LUFTDYKTIGHETSPÅBUD (LDP)

ROBINSON - 1

1056/90 MODIFIKASJON AV LUFTFILTERHUS

VEDLEGG 1 TIL LDP 056/90

Figure 1
AD 98-22-16

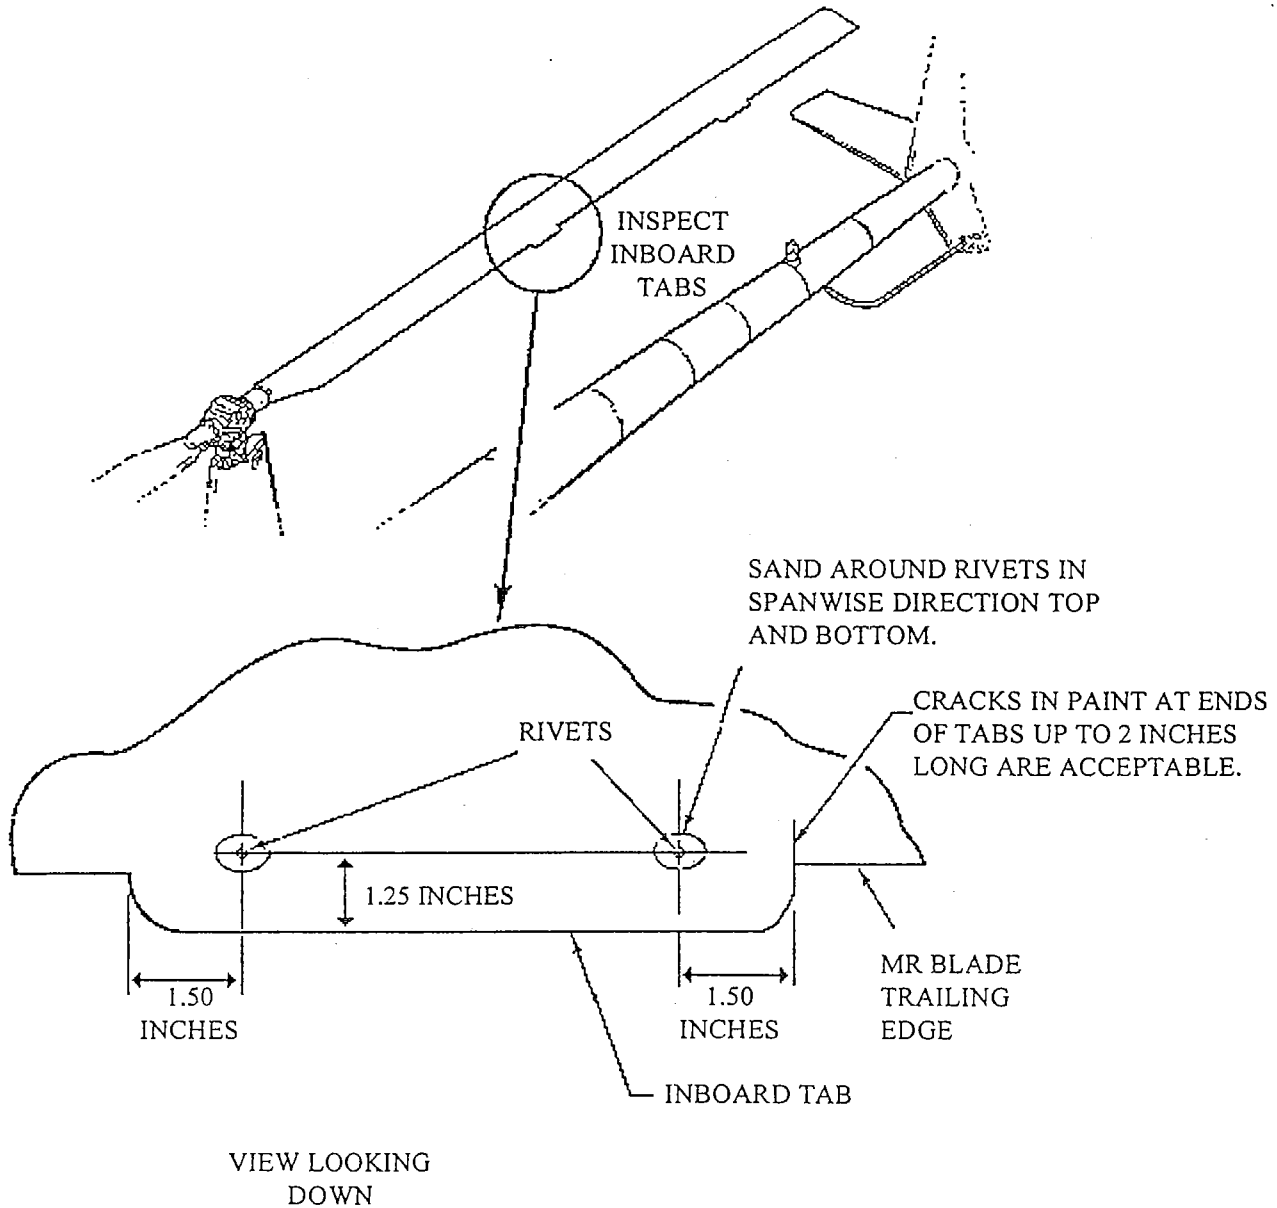
(a) Within the next 5 hours time-in-service (TIS), perform a dye-penetrant inspection of the main rotor blade skin around both inboard trim tab alignment rivets as follows, referring to Figure 1.

Figure A

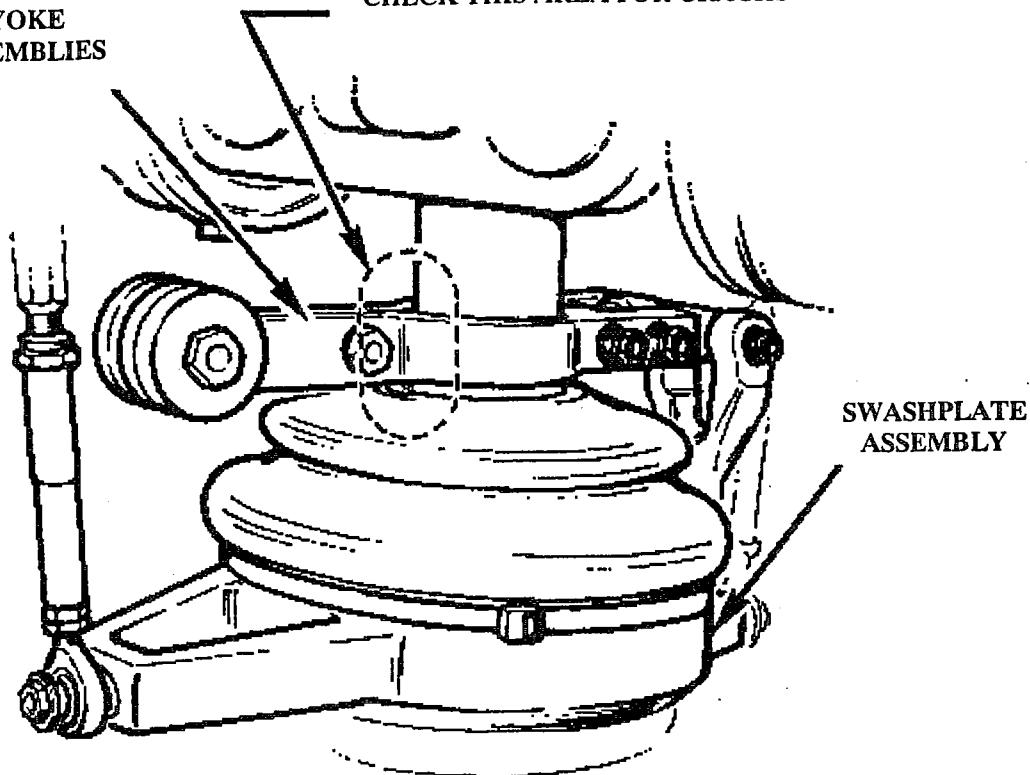
CHECK THIS AREA FOR CRACKS

Figure 1

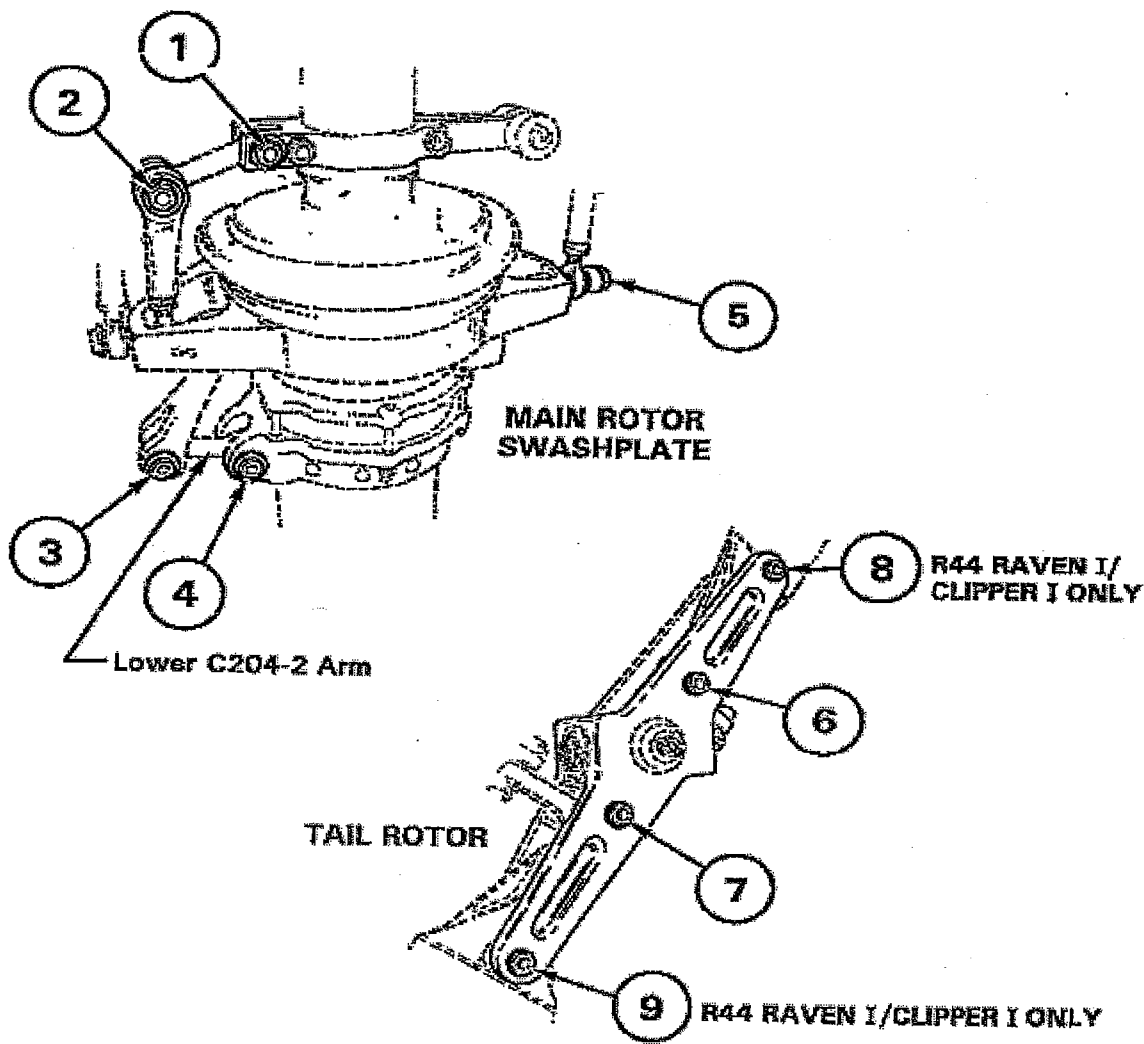
(1) Determine if maintenance has been performed after February 7, 2003 on the areas specified in Figure 1 of this AD, and determine if any bolt, part number (P/N) NAS6605-31, shown in Figure 1 has been replaced for any reason.

(2) Apply 10-15 ft-lb (13-20 Nm) torque to each bolt head and verify no rotation. See Figure 1 of this AD.

(3) If residue or rotation of the bolt is found, before further flight, replace each unairworthy bolt with an airworthy bolt that does not have a vendor identification marking of 01DO.

Figure 1

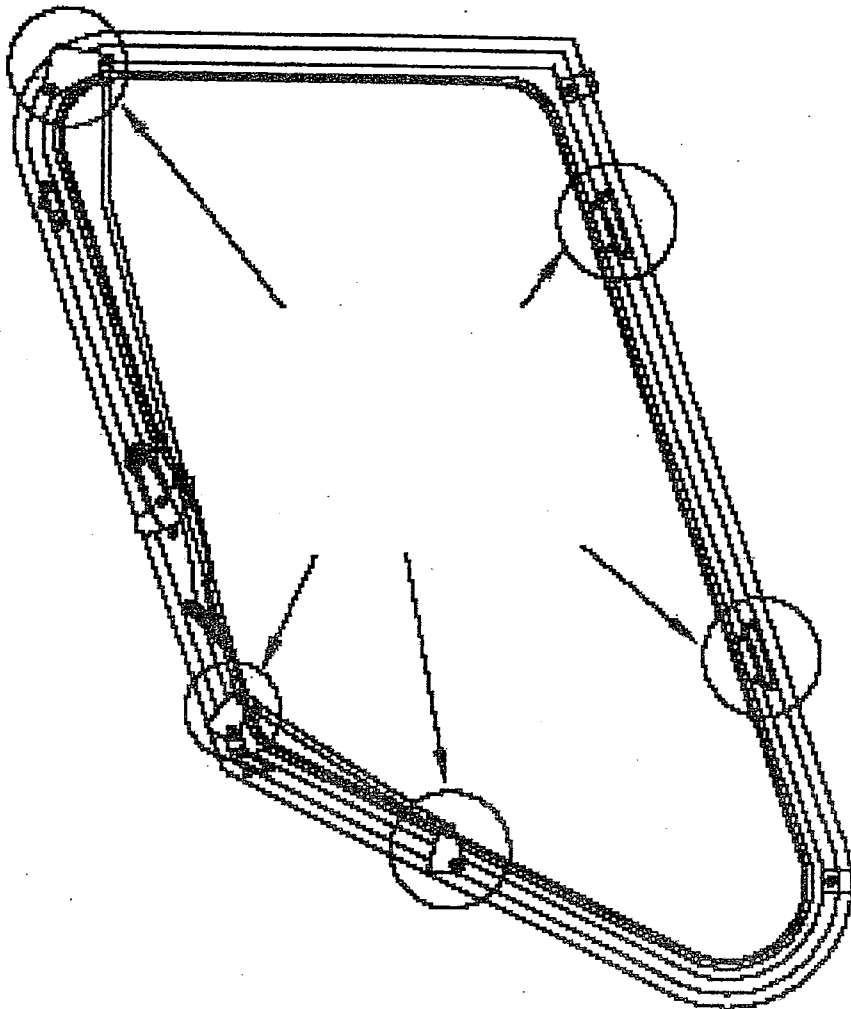
(1) Visually inspect each pilot and copilot door assembly integral frame for a crack in the locations depicted in Figure 1 of this AD. If a crack is found, before further flight, replace the cracked door assembly, part number (P/N) R-22-101-51 or P/N R-22-101-53 (left-hand door assembly), or P/N R-22-101-52 or P/N R-22-101-54 (right-hand door assembly), with an airworthy door assembly. If you use door assembly, P/N R-22-101-51 or P/N R-22-101-53 (left-hand door assembly), or P/N R-22-101-52 or P/N R-22-101-54 (right-hand door assembly) as the replacement, then install it in accordance with Tech-Tool Plastics, Inc. Installation Instructions TTP-1R, Revision A, dated November 21, 1997, and with the sections titled "Door Weather Seal Installation" and "Cotter Pin Installation" in Tech-Tool Plastics, Inc. Service Bulletin No. TTP2005-01, Revision A, dated February 1, 2005 (SB).

(b) After accomplishing the inspections in paragraphs (a) through (a)(2)(ii) of this AD, at intervals not to exceed 100 hours time-in-service, visually inspect each pilot and copilot door assembly integral frame for a crack in the locations depicted in Figure 1 of this AD.
